# Staff Report – Plan Commission

<b>Docket #:</b>	PC2026-014 Grove at Stones Crossing Lot 1	<b>Hearing Date:</b>	April 27, 2026
<b>Applicant:</b>	Justen Hochstetler, Crossroad Engineers, 115 N 17 <sup>th</sup> Ave., Beech Grove, IN 46107		
<b>Owner:</b>	Franciscan Alliance, Inc., 8111 S Emerson Ave., Indianapolis, IN 46237		
<b>Subject Property:</b>	SE Corner of SR 135 and Grove Crossing Blvd.		
<b>Staff Contact:</b>	Gabe Nelson, nelsong@greenwood.in.gov, 317.887.5230

**SITE DIMENSION PLAN**

**GROVE AT STONES CROSSING**

**C300**  
SHEET

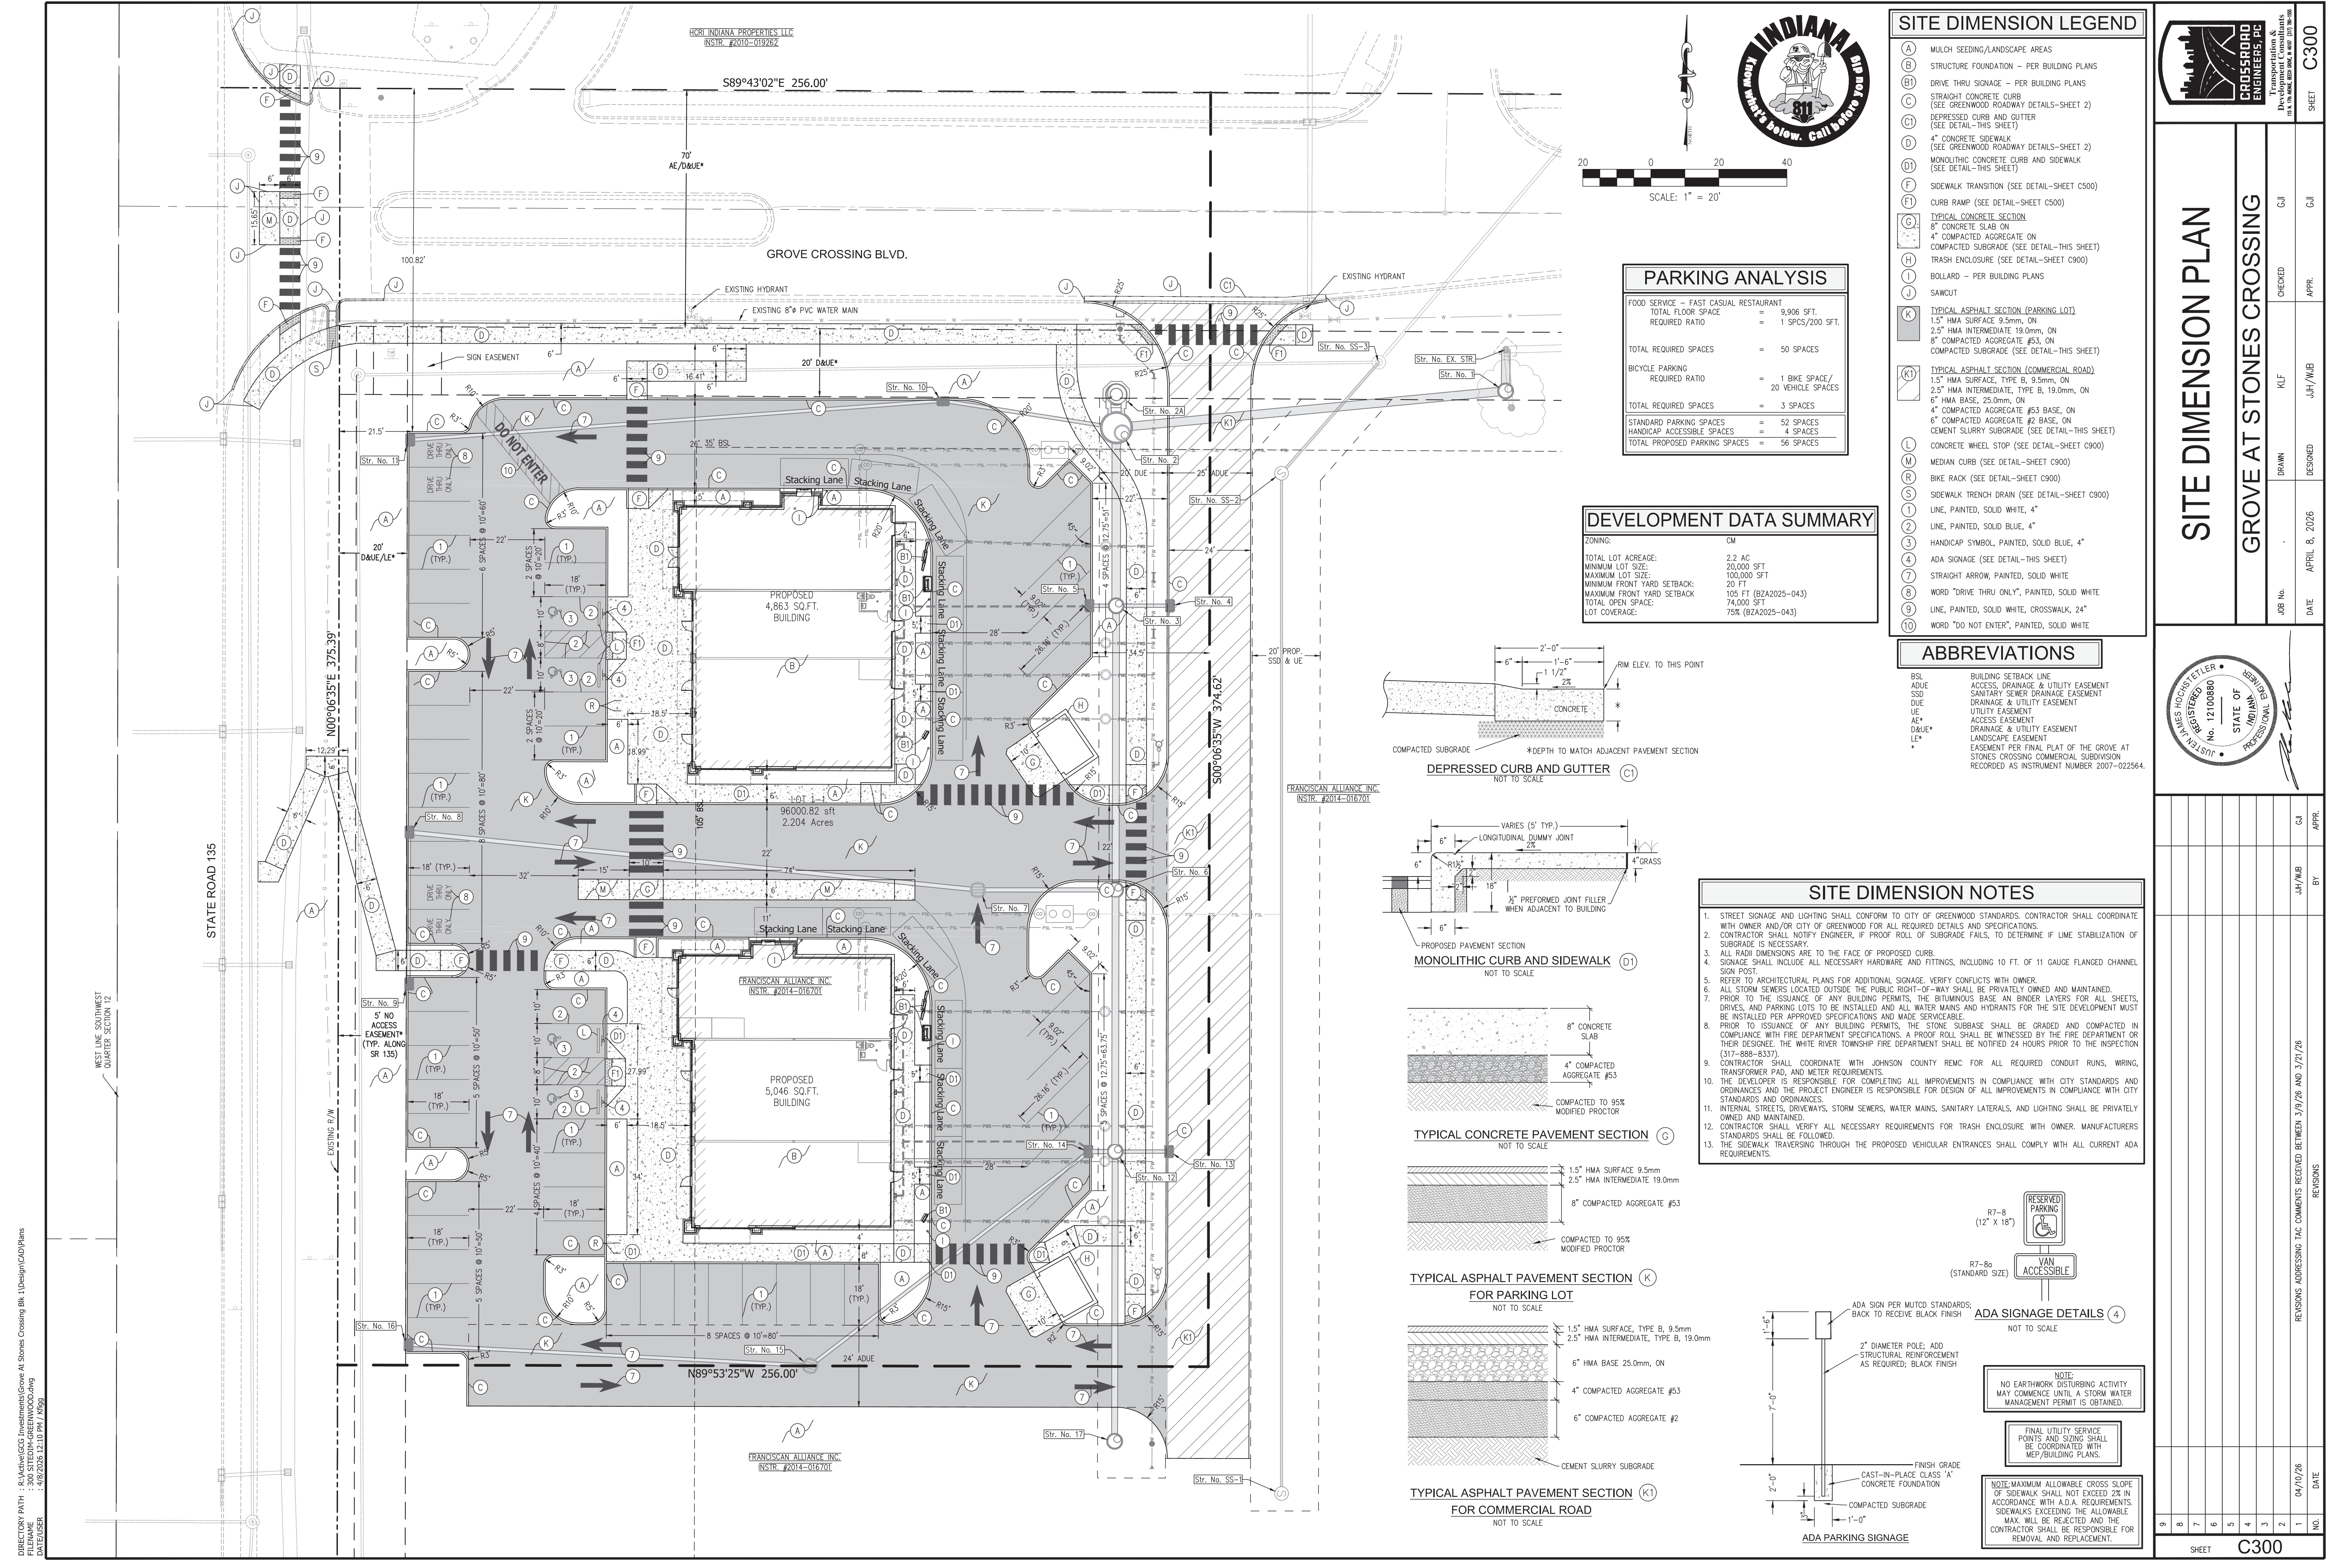
**Staff Comment:** The Board of Zoning Appeals previously approved variance increased the front yard setback along SR-135 from 80 ft to 105 ft, which provides adequate space for required landscaping. The proposed sidewalk corridor measures approximately 20–25 ft in places and can accommodate planting through planters, tree grates, or other integrated planting treatments to meet the 10-ft planting strip requirement.

**Staff Comment:** Perimeter landscaping is required for all parking lots. The building is under construction with associated parking and drive aisles; therefore parking lot perimeter plantings and perimeter plantings adjacent to drive aisles must be provided in accordance with the UDO.

**Staff Comment:** Streets include thoroughfares that afford vehicle access to abutting property. The frontage should include street trees at a rate of 1 tree per 40 feet.

**Staff Comment:** Regional trails and pathways identified in the Comprehensive Plan must be constructed to the plan’s standards. Where the Plan requires a 10-ft pathway, that width takes precedence over standard sidewalk widths; the City Engineer may reduce width only for field constraints (slope, grade, topography, etc.). Reducing the pathway width would conflict with the petitioner’s stated goal of providing generous, safe pedestrian areas. In order to uphold the Comprehensive Plan, trials should be required.

Staff recommends denial of all waiver requests.
